DA2025/006

12 JUBILEE AVENUE, BRIGHTON

### **MULTIPLE DWELLINGS X 13 (12 NEW & 1 EXISTING)**

# APPLICATION FOR PLANNING PERMIT (DA 2025 / 00006) MULTIPLE DWELLINGS X 13 (12 NEW AND 1 EXISTING), 12 JUBILEE AVENUE, BRIGHTON

DRAWN:	LG
			CHECKED:	NM
С	PRELIMINARY ISSUE - NOT FOR CONSTRUCTION	10/10/2025	DESIGN:	LG
В	PRELIMINARY ISSUE - NOT FOR CONSTRUCTION	25/09/2025	CHECKED:	NM
Α	PRELIMINARY ISSUE - NOT FOR CONSTRUCTION	7/08/2025	VERIFIED:	-
REV	ISSUE	DATE	APPROVAL

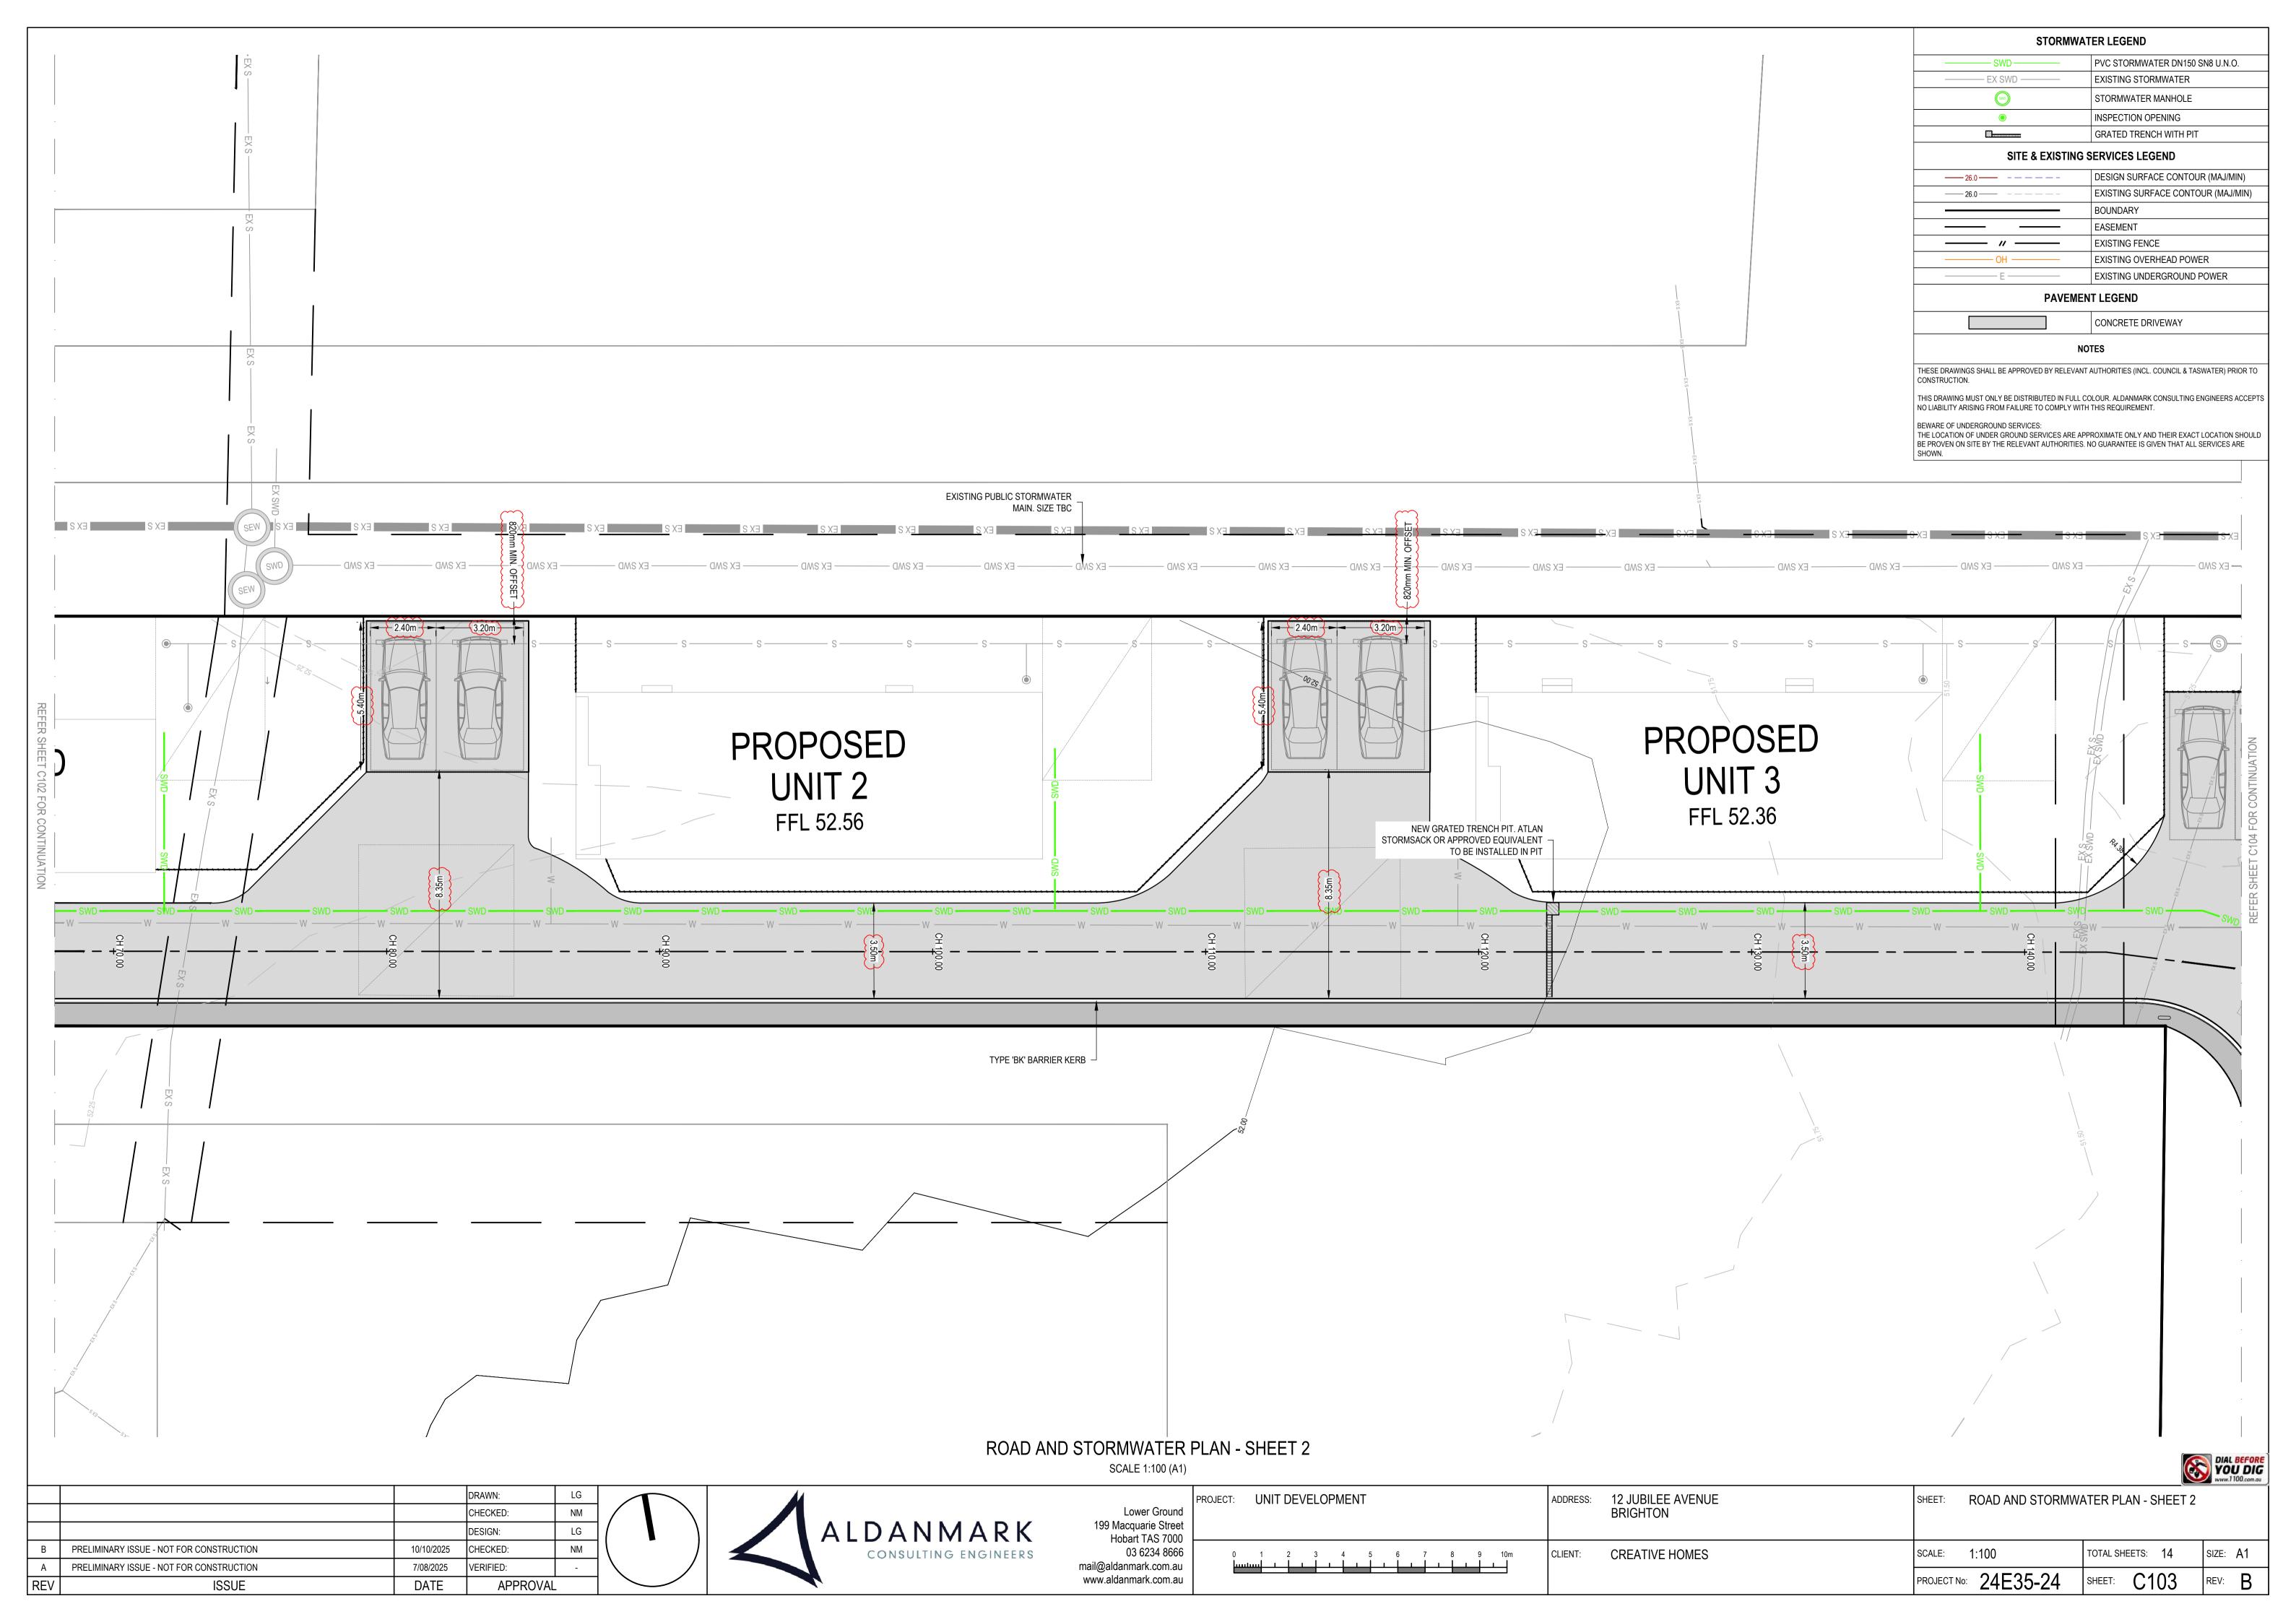
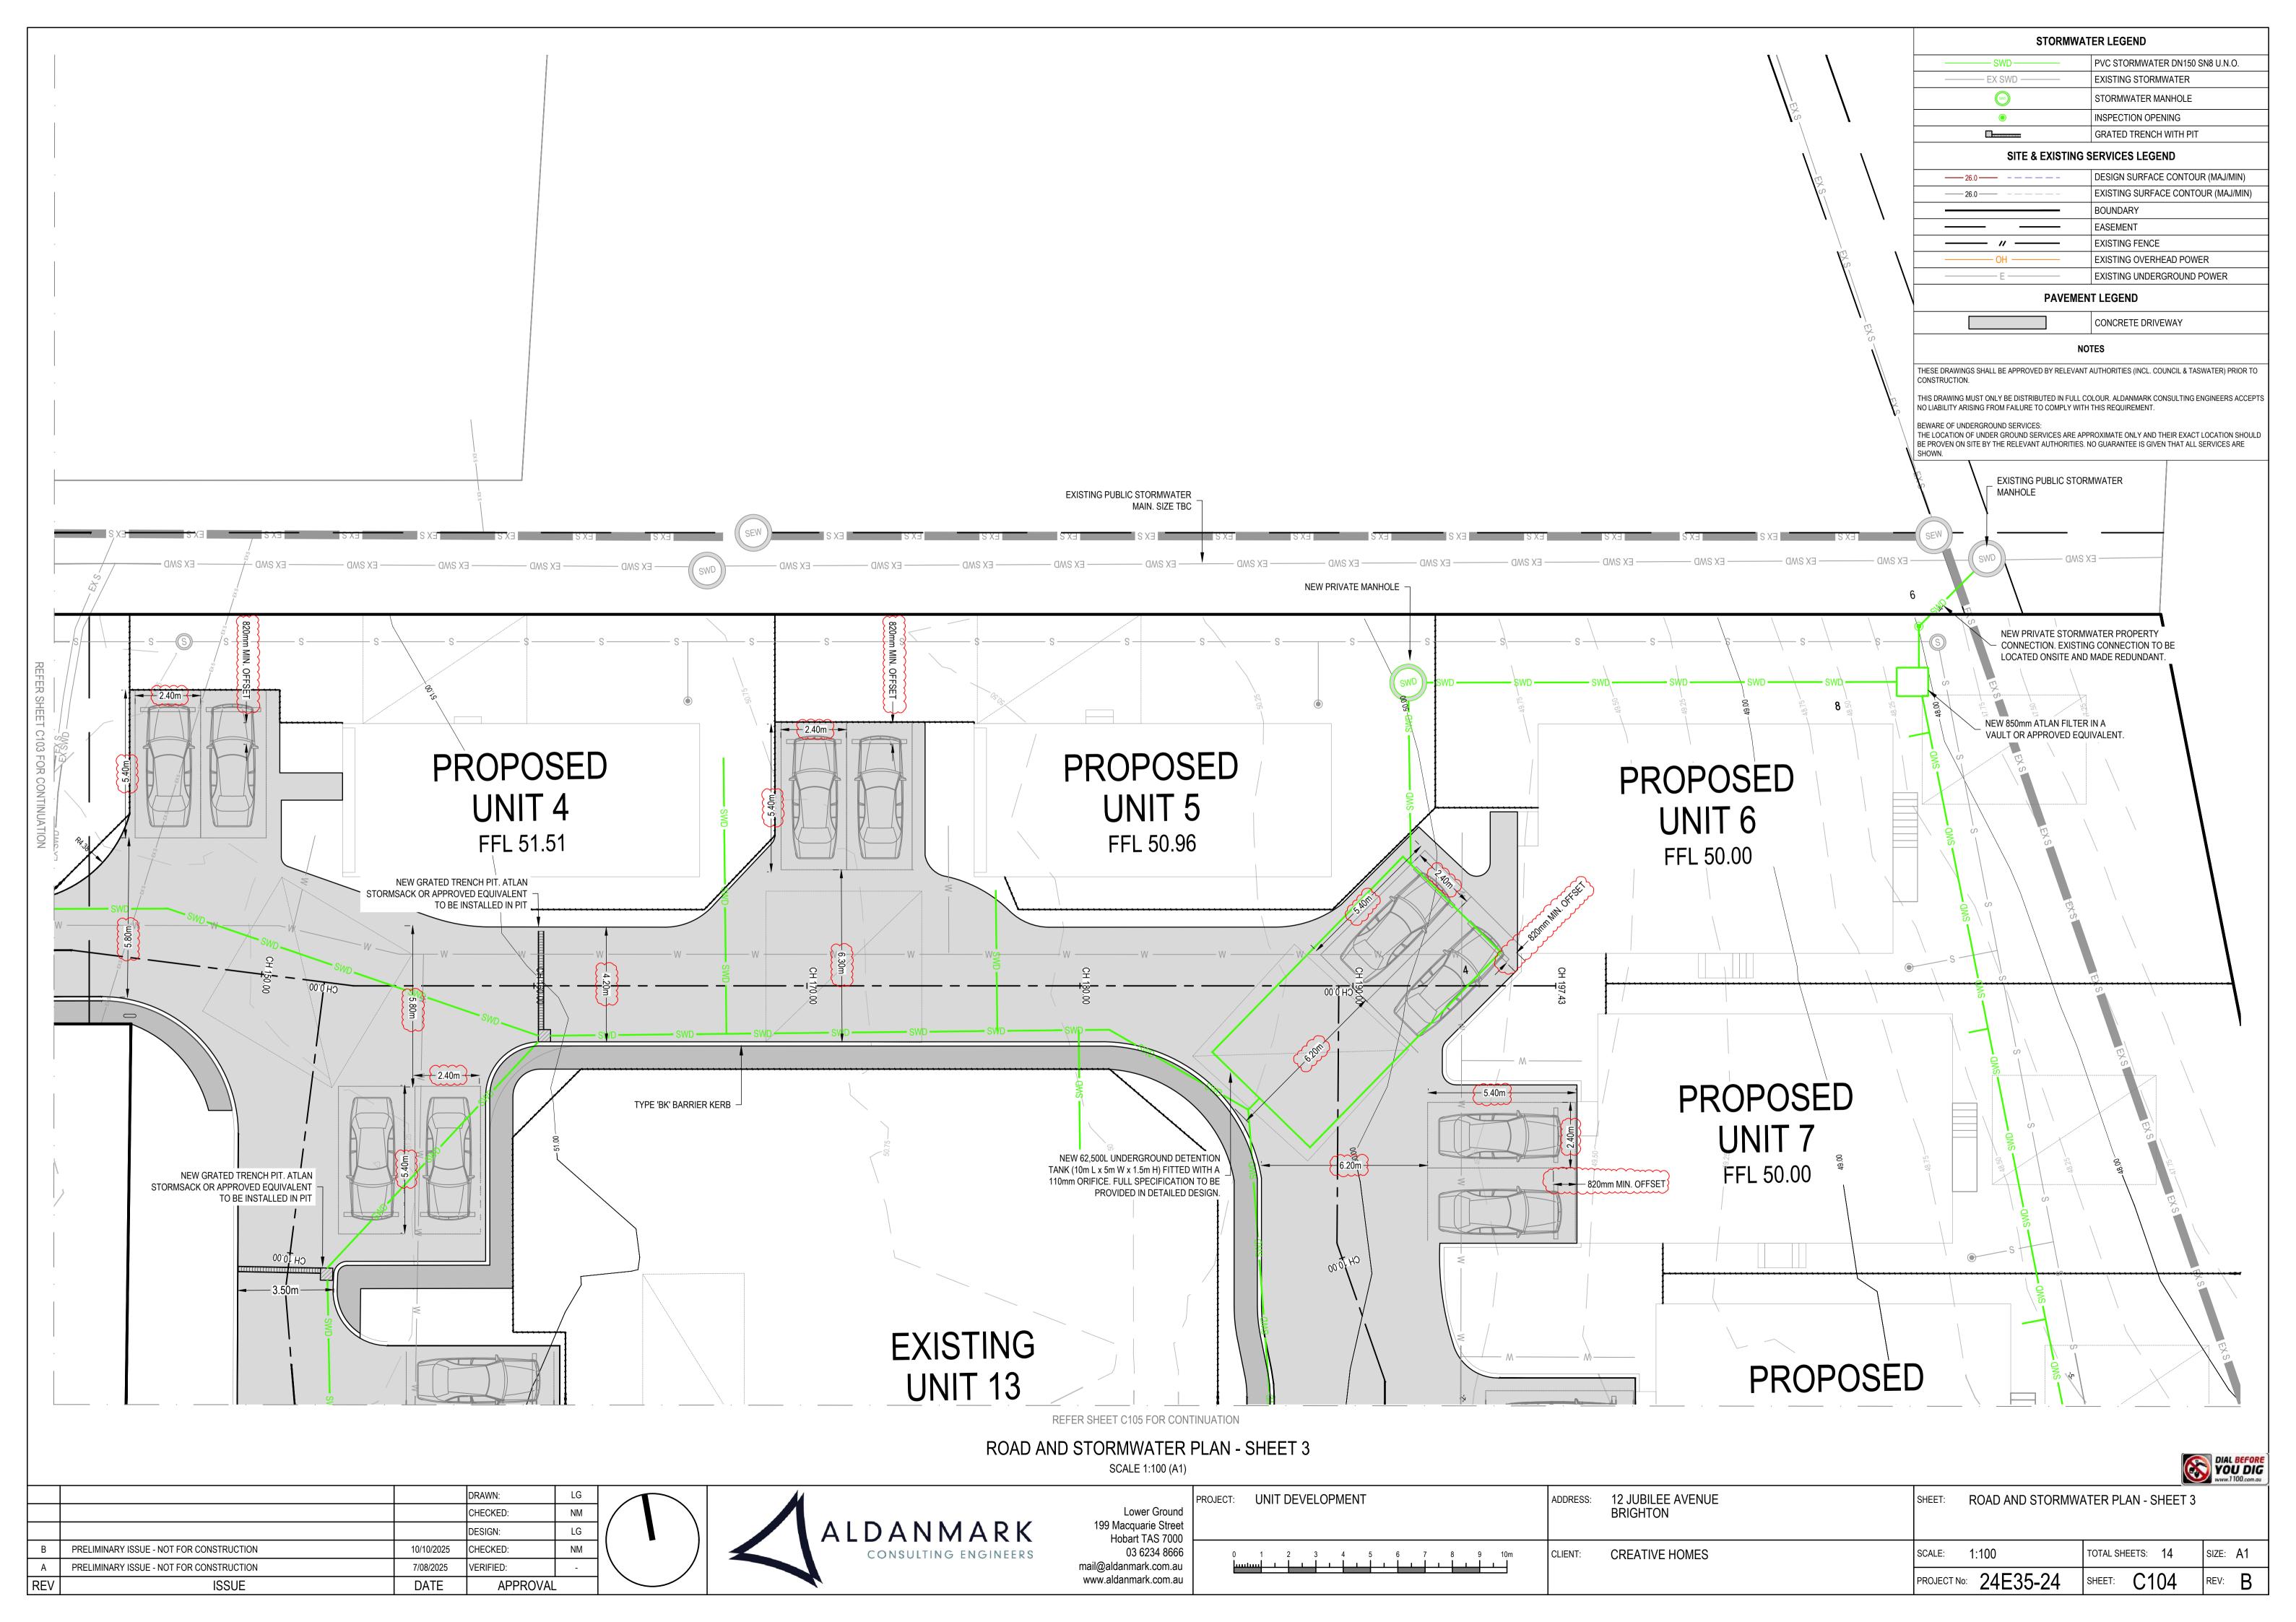
RFI CONDITION	COMMENTS	AMENDMENTS	ALDANMARK DRG REFERENCE	
4(a)	Provide a revised plan set that addresses C2.6.2 A1.1 (iii) in particular providing a 5.5m carriage way throughout or provides passing bays that include workable tapers and are orientated to accommodate the flow of traffic. Turning sweeps should be shown at each passing bay.  Adequate tapers have been provided for all passing bays, are oriented to the flow of traffic and have turning paths shown as per Sheets C110 – C113 RevB			
4(b)	Provide a revised plan set that addresses C2.6.2 A1.1 (v) provide parking bays throughout that meet the requirements of Table C2.3 including which do not encroach upon pedestrian access ways.	No parking bays are shown encroaching on pedestrian access ways.	C110 – C113 RevB	
4(c)	In accordance with 2.6.5 A1.1 parts (a) and (b) including with a pedestrian throughfare that has a surface raised 150mm above that of the roadway and is not encroached with vehicle reversing.	Type 'BK' Barrier Kerb as per LGAT drawing TSD-R14-v3 has been noted on Sheets C102 - C105 RevB. Footpaths match into the back of 150mm high kerb. Aisle widths from the carpark to the kerb have been shown on Sheets C102 - C105 RevB for all car parks and are above the minimum requirement of 5.8m for User Class 1A as per AS2890.1. This allows for adequate space for reversing without encroaching, as deemed by AS2890.1	C102 - C105 RevB

N/a	Council comment regarding Unit 4 passing bay:  Picture above of the internal intersection change of direction occurring at unit 4 that has not been taken into account if a vehicle wishes to turn left entering from the right. Proof or an understanding of this action is required.	Aldanmark considers the vehicle entering from the right and turning left at the intersection outside of Unit 4 an improbable scenario. Only vehicles accessing the existing dwelling and the proposed Unit 12 will enter this section of the driveway, which would be from the left of page. This intersection is the widest	C113 RevB

part of the driveway which has sufficient space for turning and an adequate carriageway width of 3.5m has been provided at the exit to the existing dwelling and proposed Unit 12.	
12	It is noted that 16 Creed Court currently provides overhead power supply to 12 Jubilee Avenue via	This is not Aldanmark's decision. Creative Homes to address.	N/a
	a private pole. Please confirm whether this existing overhead supply will be removed and replaced with an underground connection.
